STAFF REPORT

Subject: Appeal of Hearing Officer's Decision – Application No. HPCA 1700451
2330 N. 12th Street (Lot 11), Coronado Historic District

**Staff Report
Certificate of Appropriateness
2330 North 12th Street (Lot 11) – Coronado Historic District
Case No. HPCA 1700451**

1 PRELIM SITE PLAN
 SCALE: 1/8" = 1'-0"

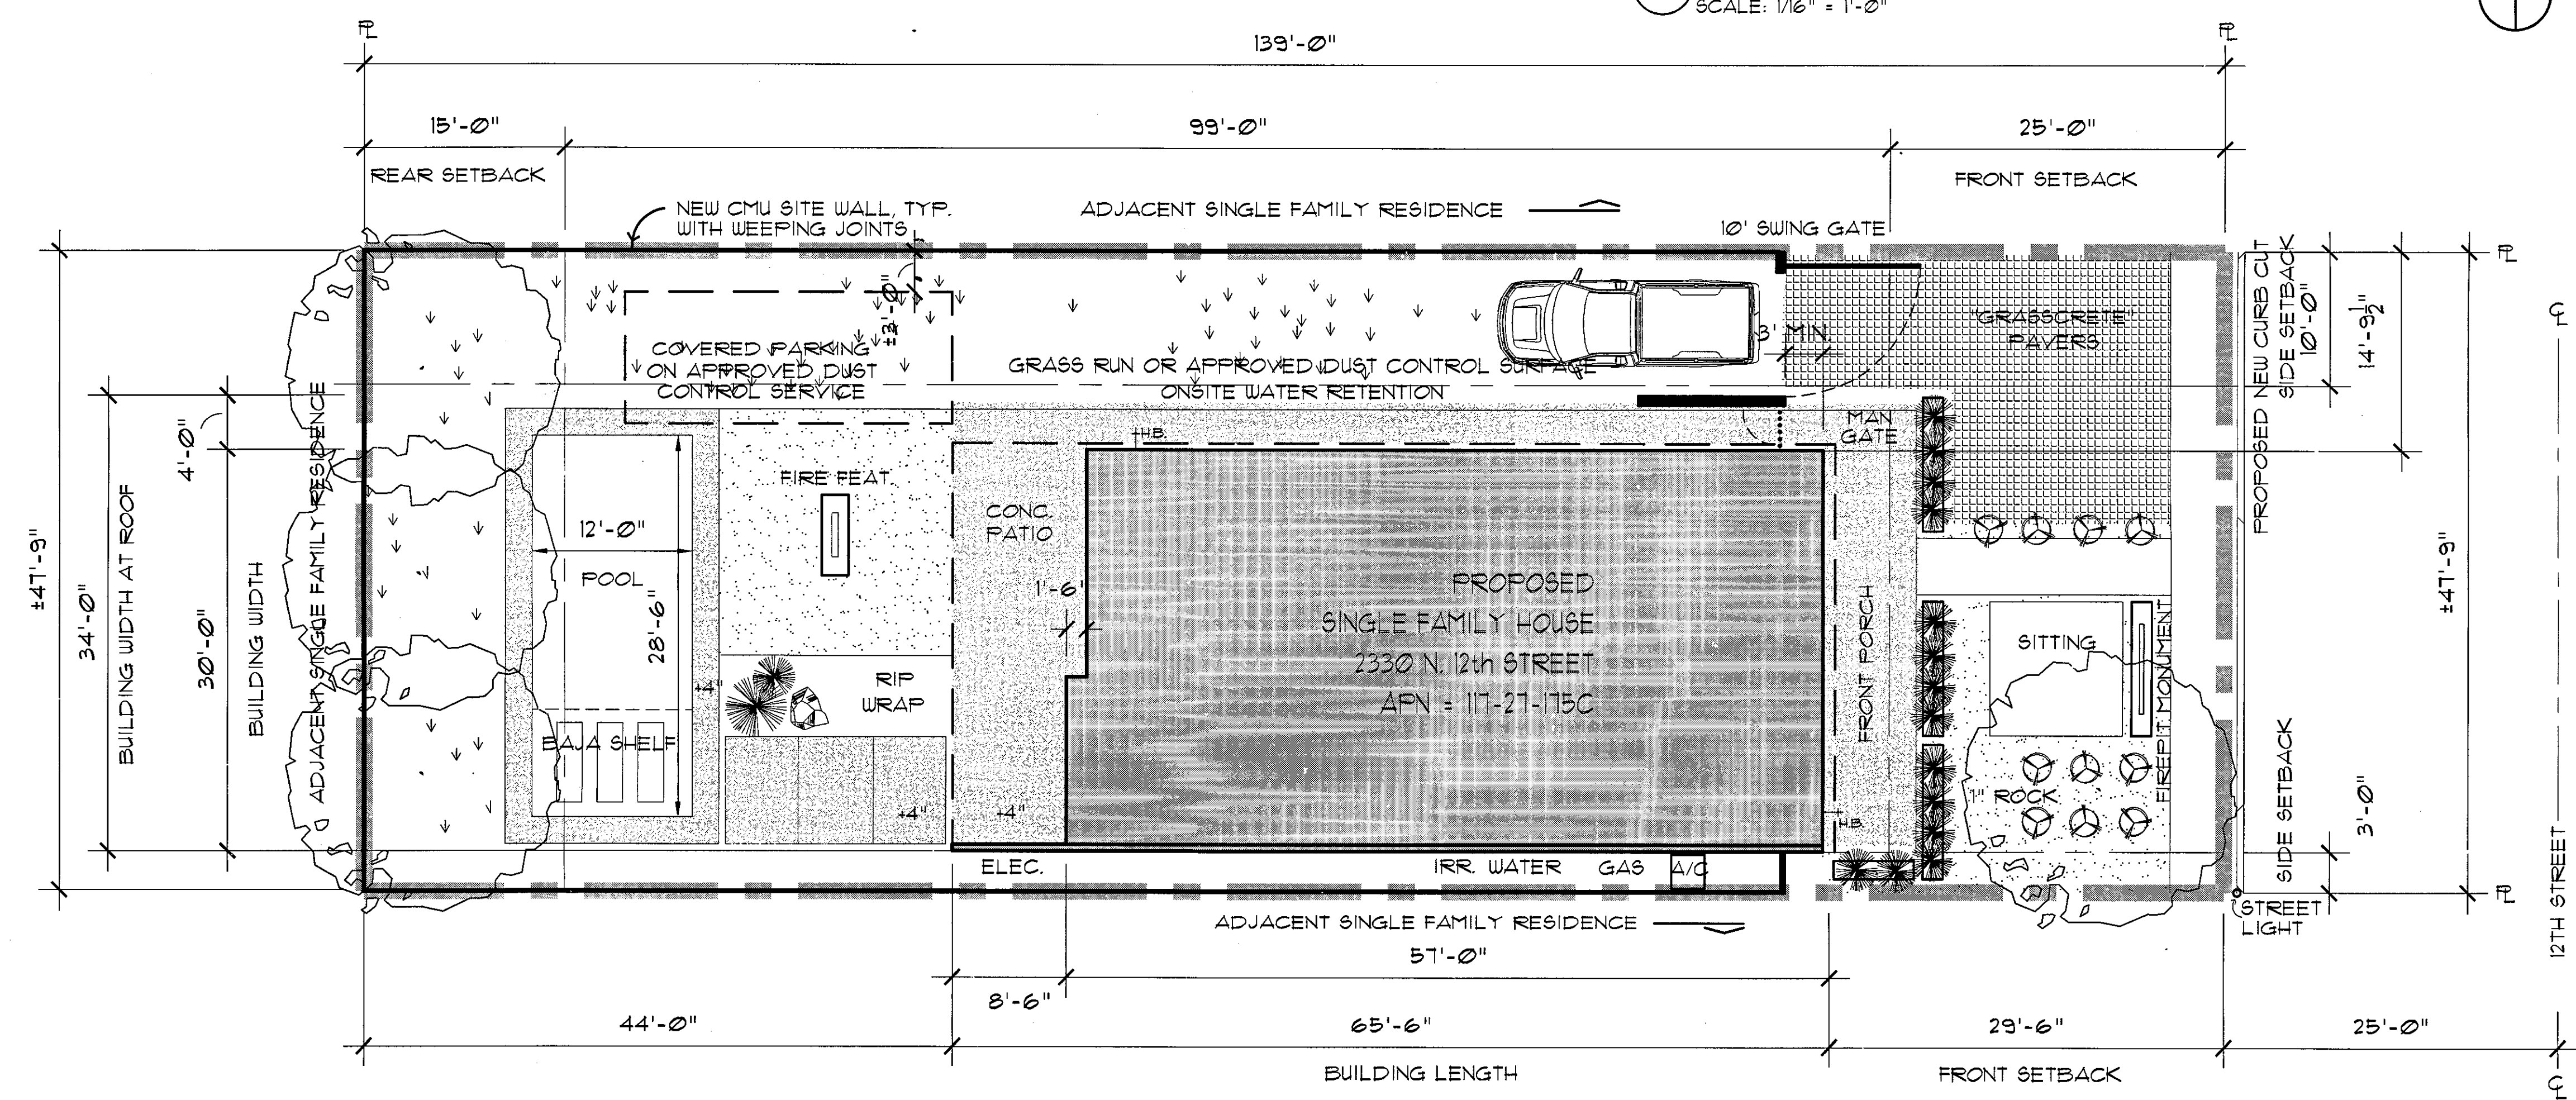
1. That the plans specify that the new CMU site wall will be 6 feet in height or lower; and
2. That a detail be provided of the proposed curb cut to ensure its compatibility with existing curb cuts on 12th Street.

2 FRONT / EAST ELEVATION
SCALE: 1/4" = 1'-0"

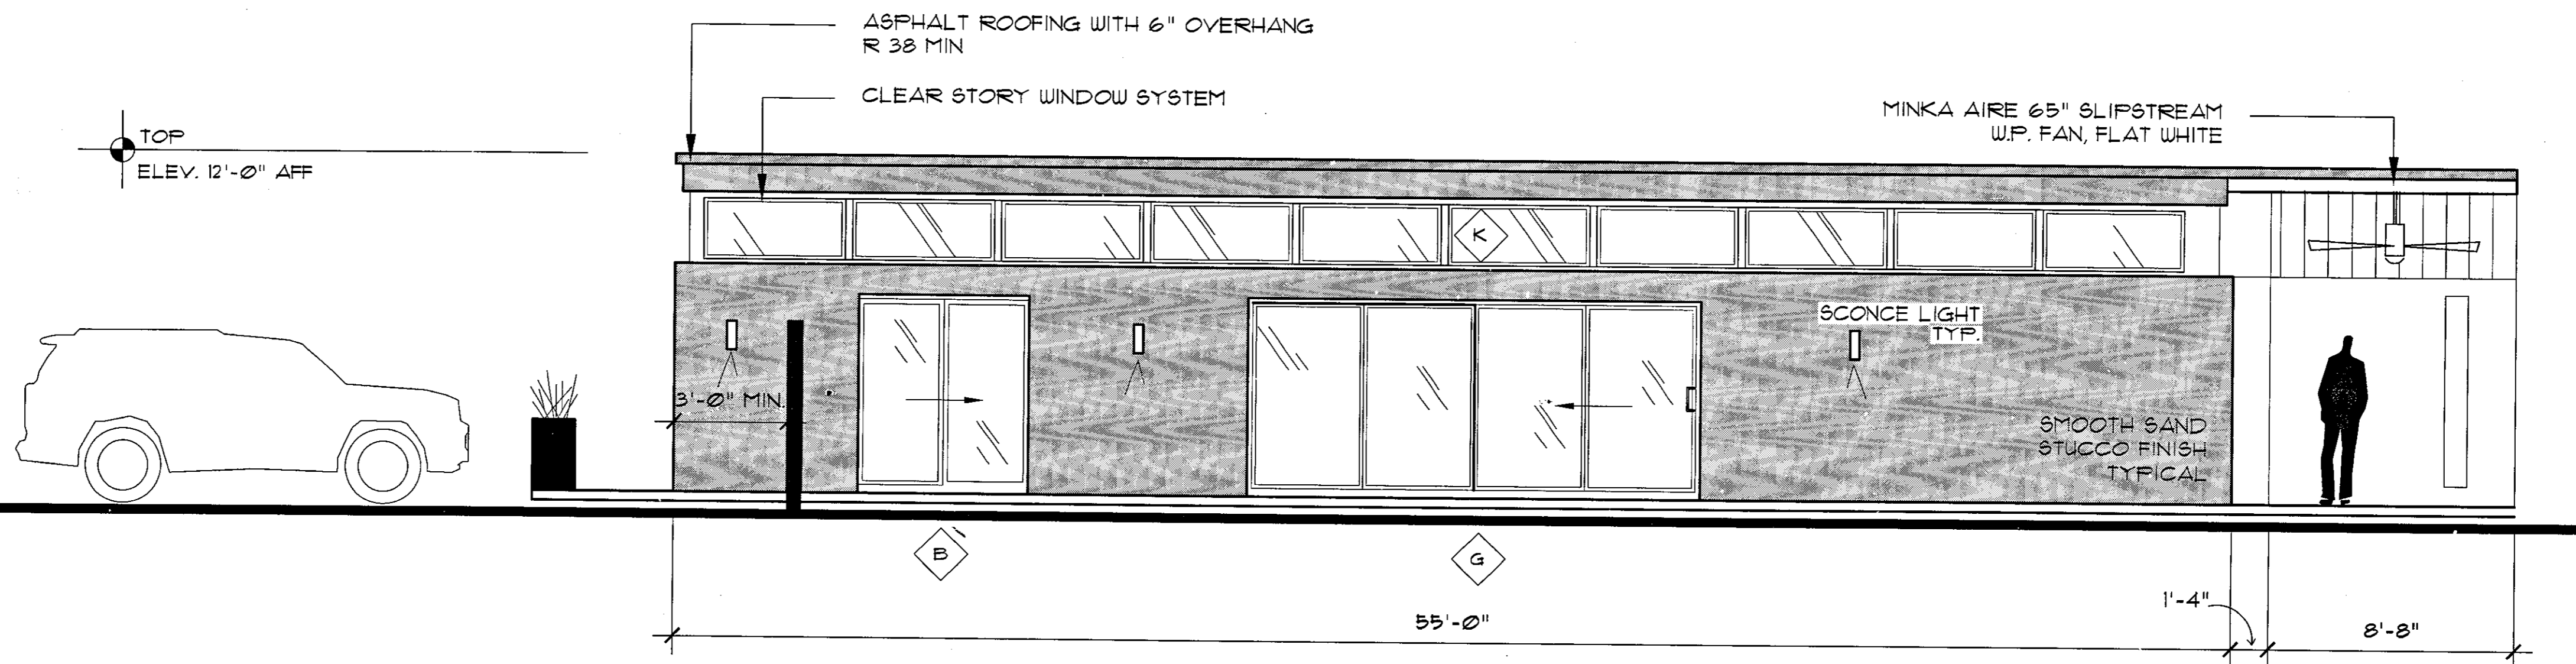
1. COMPATABILITY WITHIN CONTEXT
2. PARKING IN FRONT YARD
3. FRONT PORCH
4. ROOFLINE
5. NO WINDOWS ON FACADE "EYES ON THE STREET"
